ARCHITECT'S SUPPLEMENTAL INSTRUCTIONS

PROJECT:	Roosevelt Lofts Historic Rehabilitation San Angelo, TX	Report No.	Ten (10)
OWNER:	Overland Property Group 234 N. Santa Fe Ave, Suite A Salina, KS 67401	Date	Feb. 27, 2025
CONTRACTOR:	MCP Group 3501 SW Fairlawn Rd. Topeka, KS 66614	Architect's Proj No.	22-3281
		Contract For:	General Construction Mechanical, Electrical

1. Revised Sheet A2.9

A FIRST FLOOR FLOOR FINISH PLAN
 1/8"=1'-0"

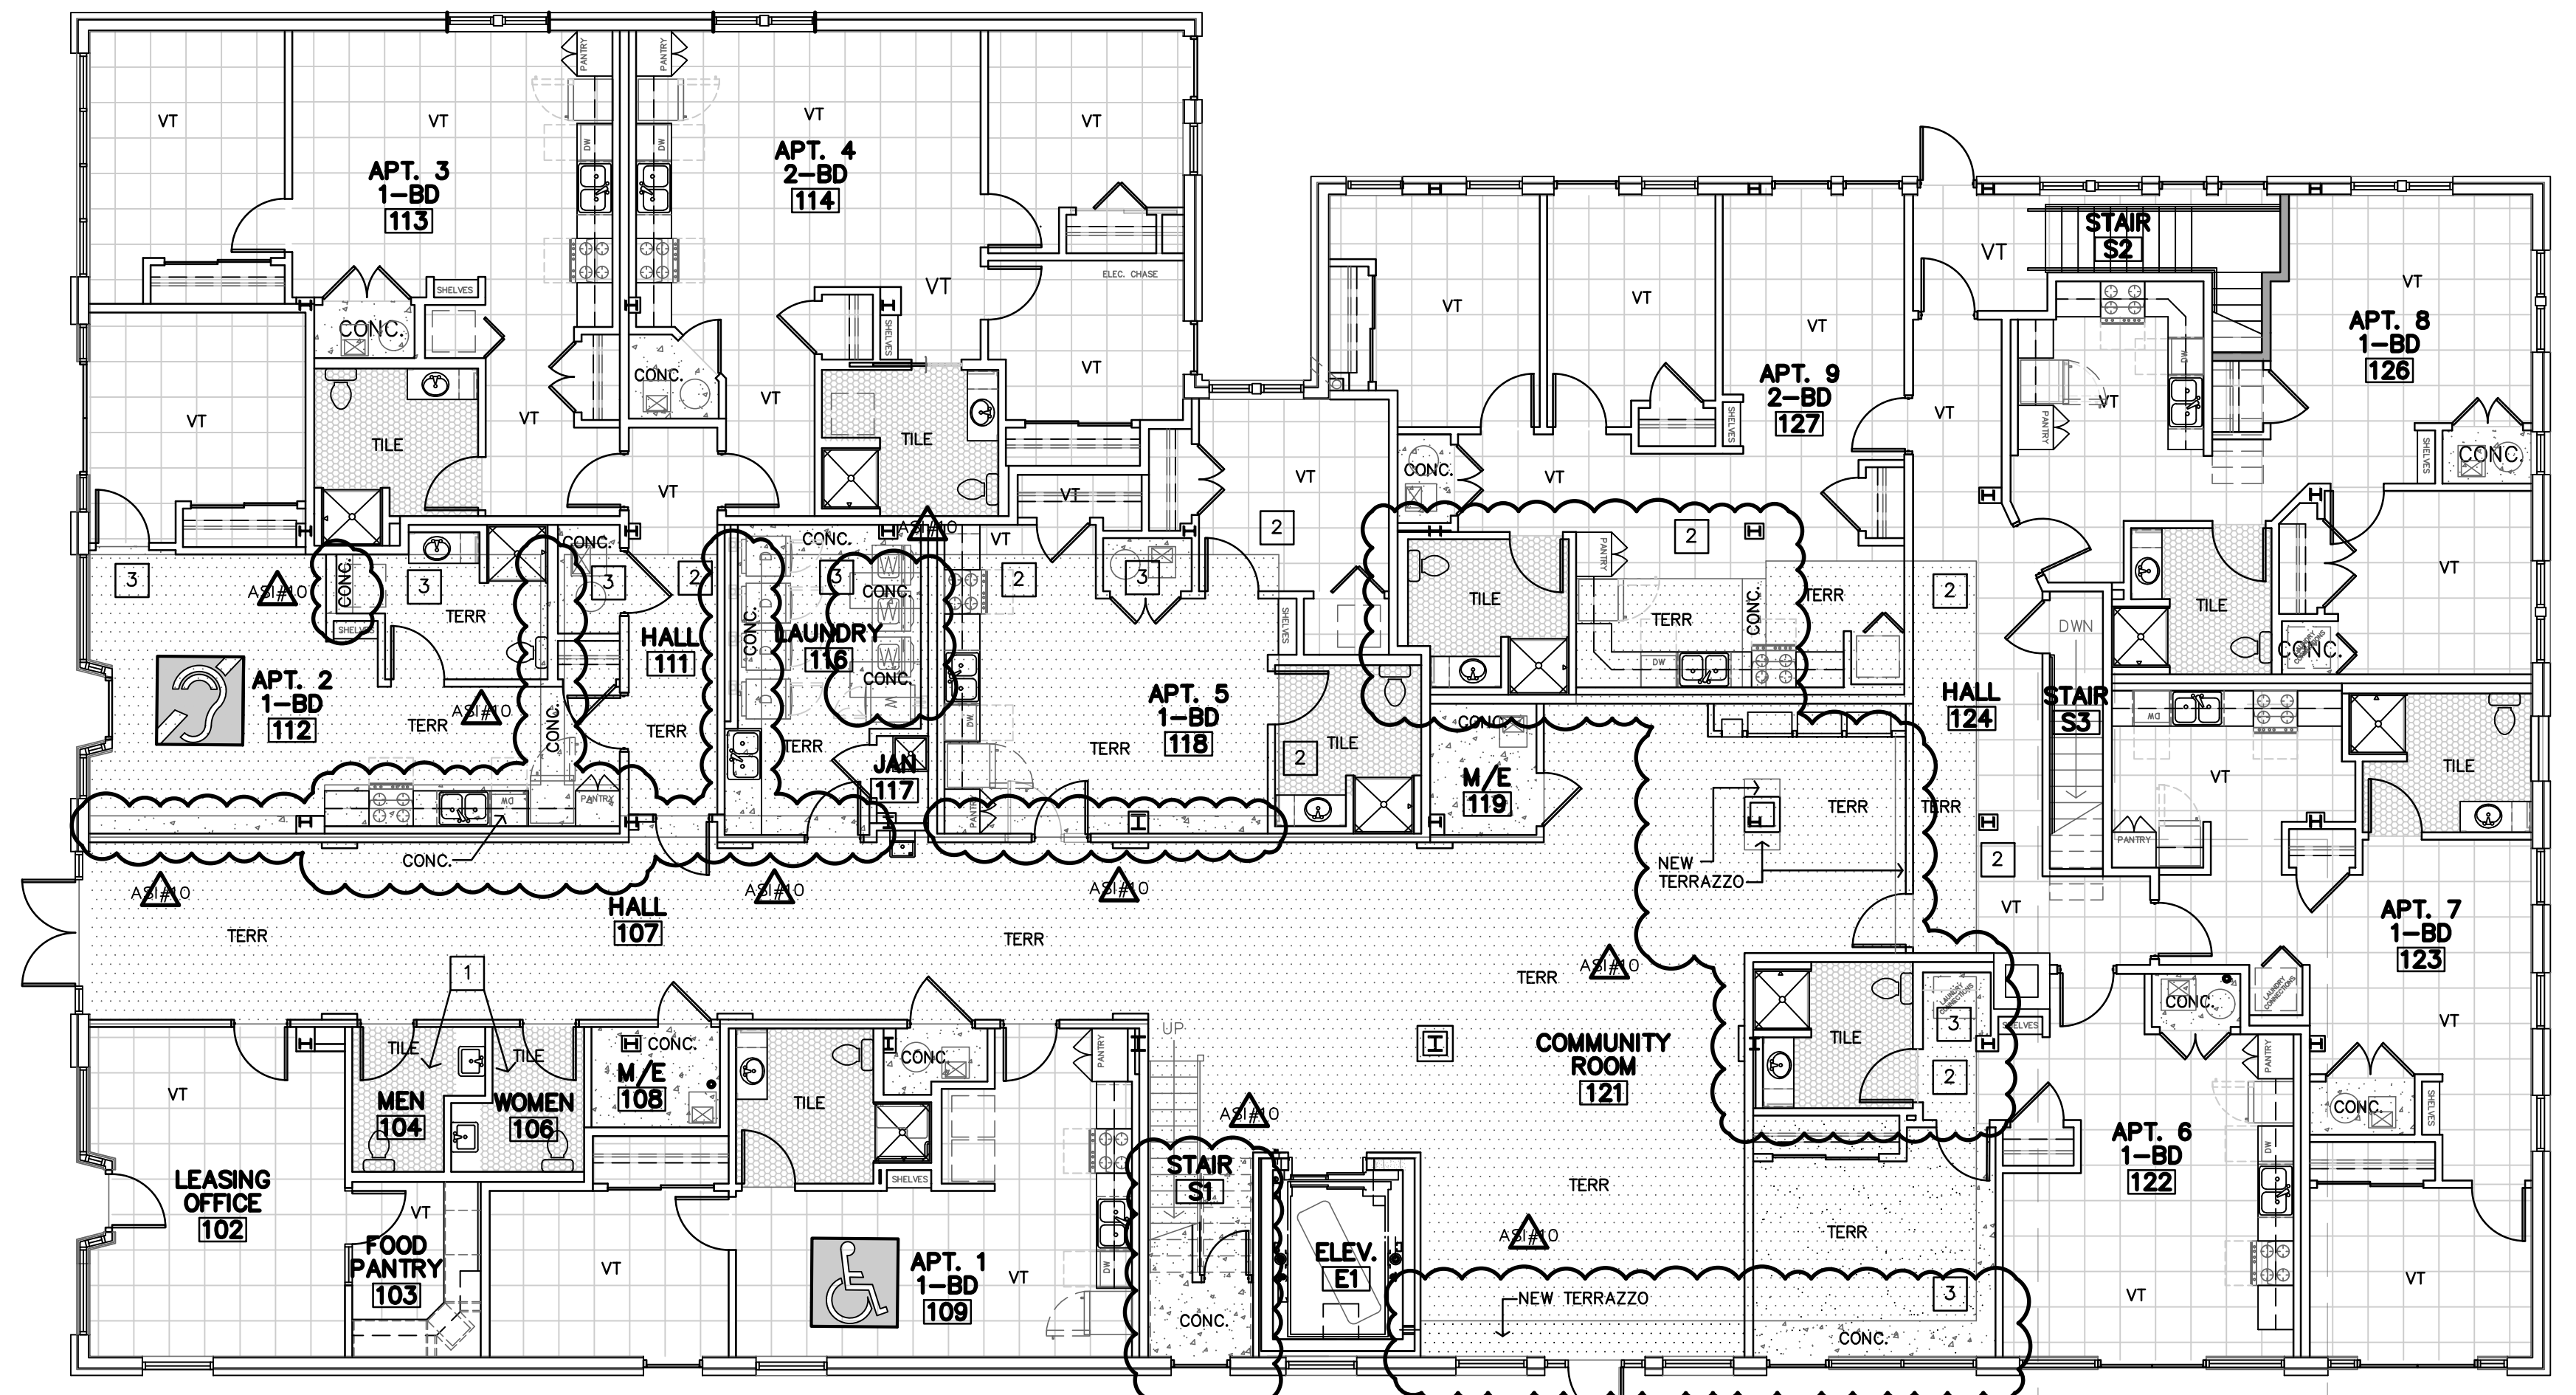
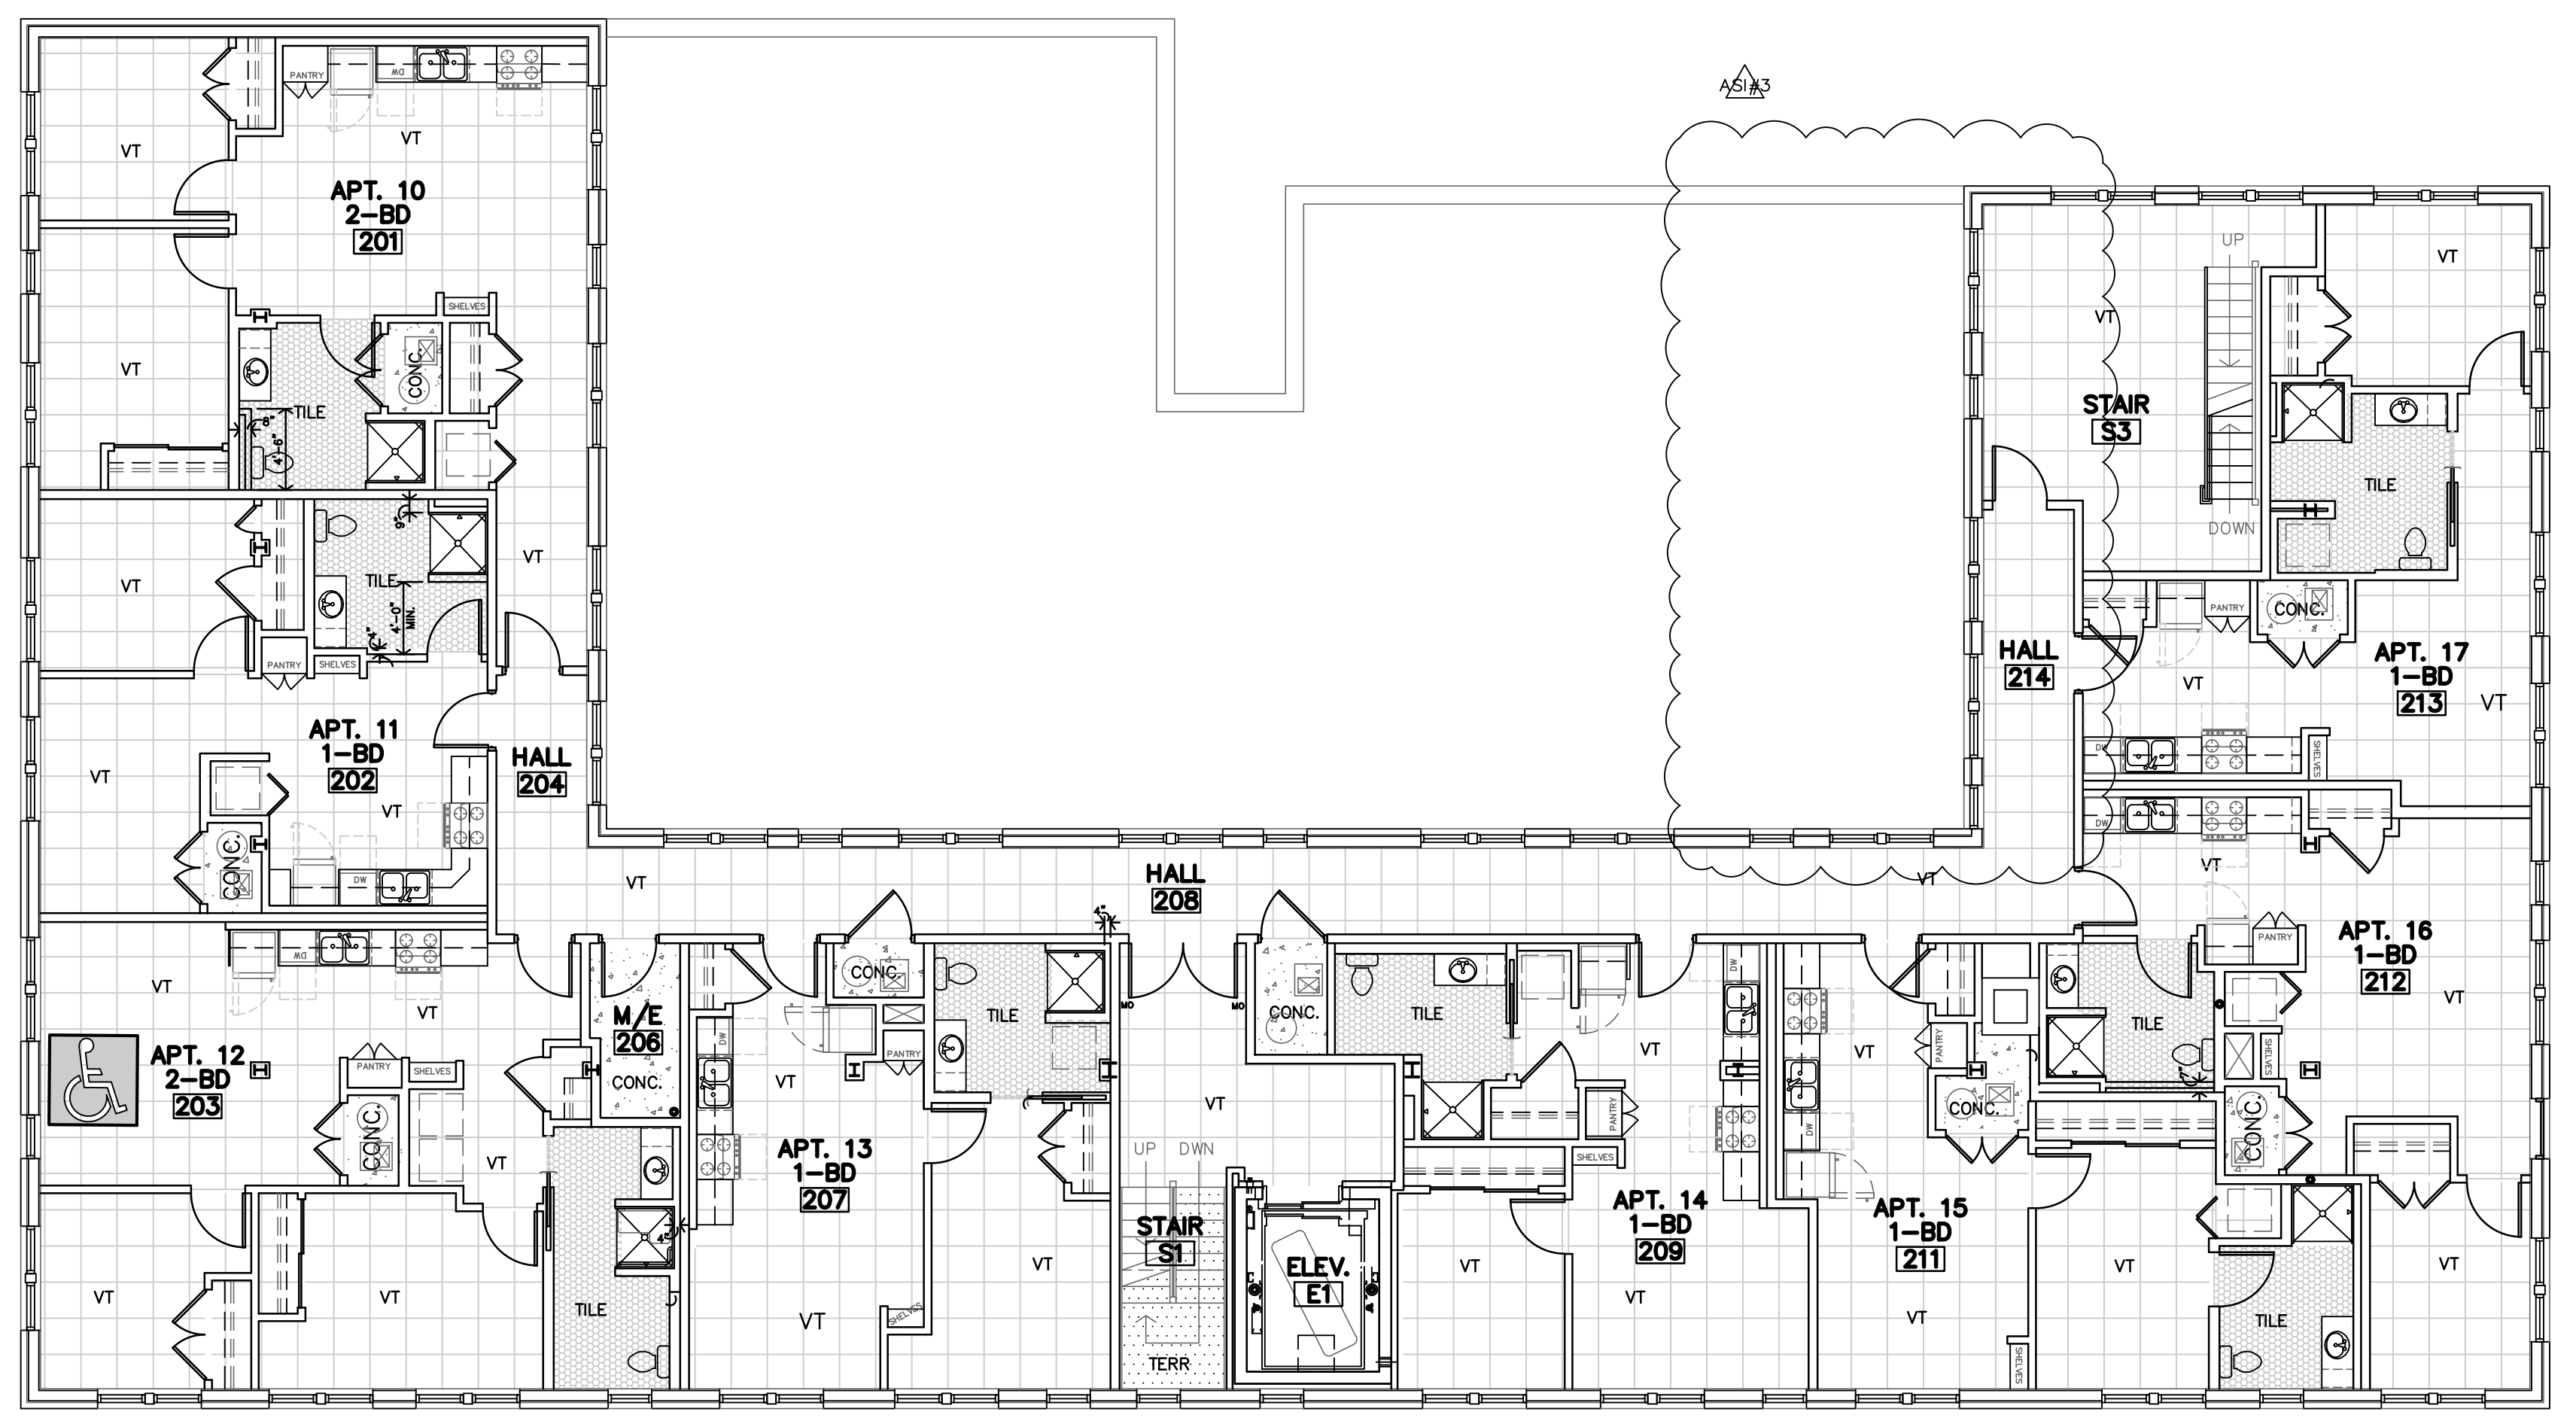
1. First Floor – Finished Floor Changes
 - a. Apartment 2 (#112)
 - i. Concrete along south wall of living room is shown wider, at approx. 12".
 - ii. Concrete underneath kitchen cabinets, is wider, shown approx. 4" past the cabinets.

- iii. Concrete runs across from kitchen to back wall of bathroom, shown approx. 16" wide.
 - iv. Concrete across back of laundry alcove, shown approx. 12" wide.

- b. Hall #107
 - i. Concrete along alcove & door opening into Hall #111, approx. 14" wide
 - c. Laundry #116
 - i. Concrete along south wall is shown wider, at approx. 12".

- ii. Concrete along west wall is shown approx. 18" wide.
 - iii. Concrete patches under washing machines (2 shown), approx. 48" x 24".
 - d. Apartment 5 (#118)

- i. Concrete along south wall is shown wider, at approx. 12".
 - e. Community Room #121
 - i. S1 – Concrete underneath stair, adjacent to Elev.
 - ii. New Terrazzo patch to match existing along south wall, adjacent to entry door.

- iii. New Terrazzo patch to match existing around column in NE corner.
 - iv. New Terrazzo patch to match existing along east wall, at door opening into Hall #124.

- f. Apartment 6 (#122)
 - i. Concrete along south wall of bedroom, approx. 24" wide.
 - ii. Concrete along north wall, behind laundry alcove, approx. 12" wide.

- iii. Mosaic Ceramic tile in bathroom, to match other apartment bathrooms.
 - g. Apartment 9 (#127)
 - i. Vinyl Tile extended further into Kitchen area, approx. 12" additional.

- ii. Concrete strip at kitchen, extending from VT area to south wall, approx. 16" wide.
 - iii. Mosaic Ceramic Tile in bathroom, to match other apartment bathrooms.
